**METROPOLITAN GOVERNMENT OF NASHVILLE AND DAVIDSON COUNTY**

**STAFF RECOMMENDATION**  
**945 Mansfield Avenue**  
**February 17, 2016**

**Application:** New construction – outbuilding; Detached Accessory Dwelling Unit

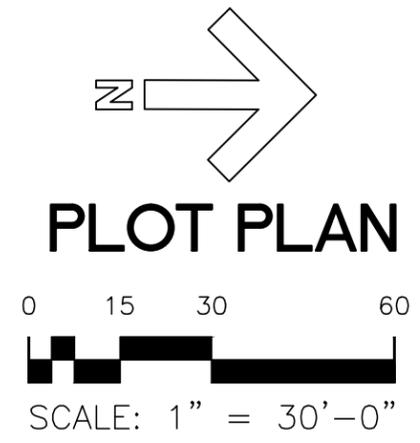
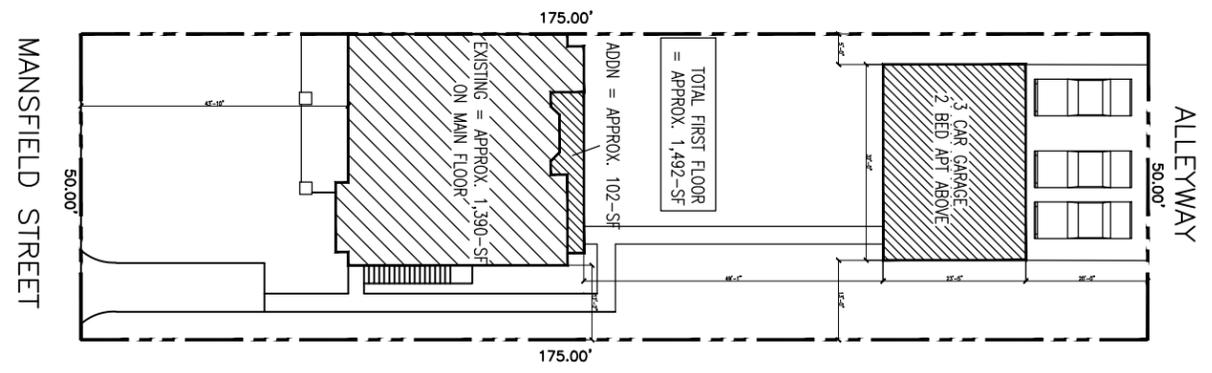
Materials, Texture, and Details and Material Color: The materials for the outbuilding have all been approved by the Commission in the past. The cladding material for the new building will have cement-fiberboard clapboard siding on the first story with a reveal matching the siding on the house, with stucco on the upperstory walls. The roof will be asphalt shingles, matching the roof on the historic house. The materials of the windows and doors are not indicated, so Staff asks to approve the final selections for the windows and doors prior to purchase and installation. Staff also recommends that windows in the clapboard walls have four inch (4”) flat casings and that there are four inch to six inch (4”-6”) mullions between abutted windows.

With the conditions that the windows and doors are approved by Staff and that openings in clapboard walls have four inch (4”) mullions and trim, Staff finds that the outbuilding would meet section II.B.1.d of the design guidelines.

# FIRST FLOOR GARAGE PLAN

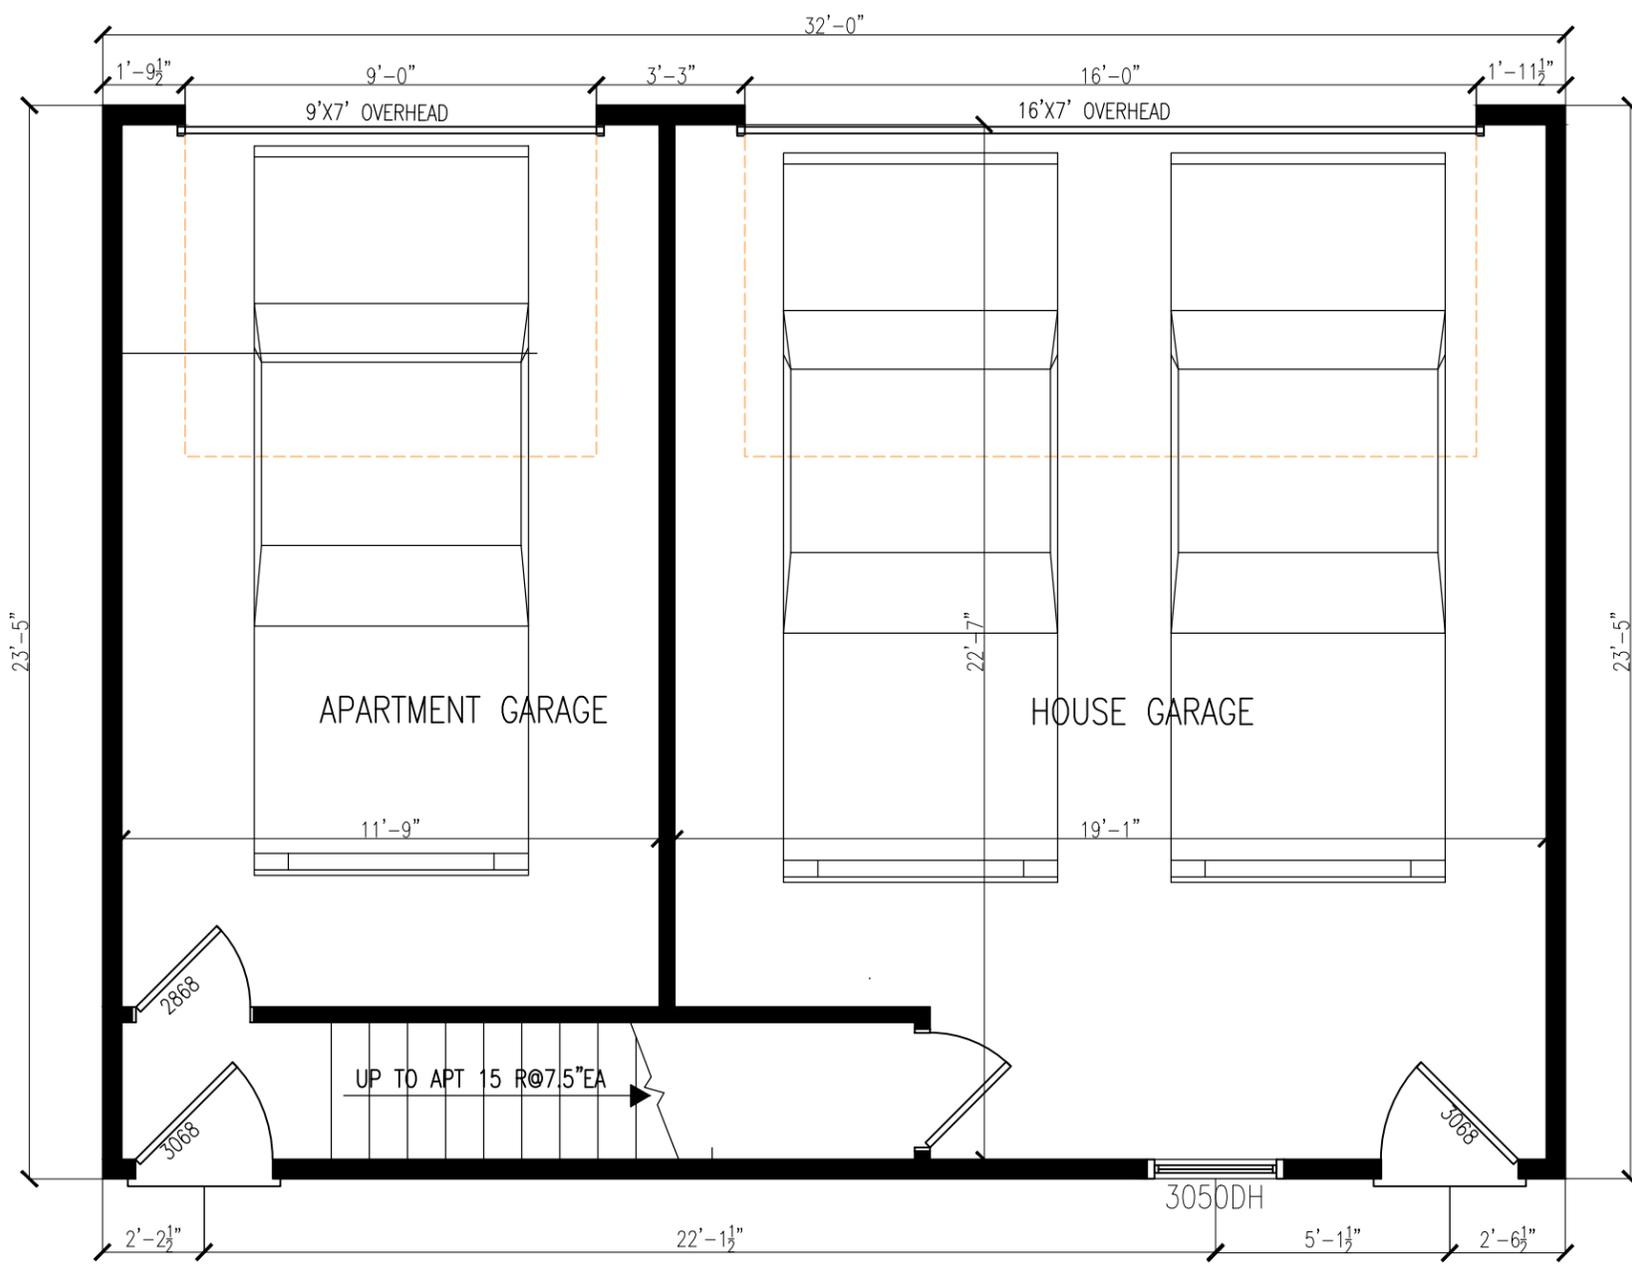
Height & Scale: The proposed DADU will be one-and-a-half stories tall with a footprint of seven hundred and fifty square feet (750 sq. ft.). The total living space in the outbuilding will be approximately five hundred, fifty square feet (550 sf). The eave and ridge heights will match those of the historic house.
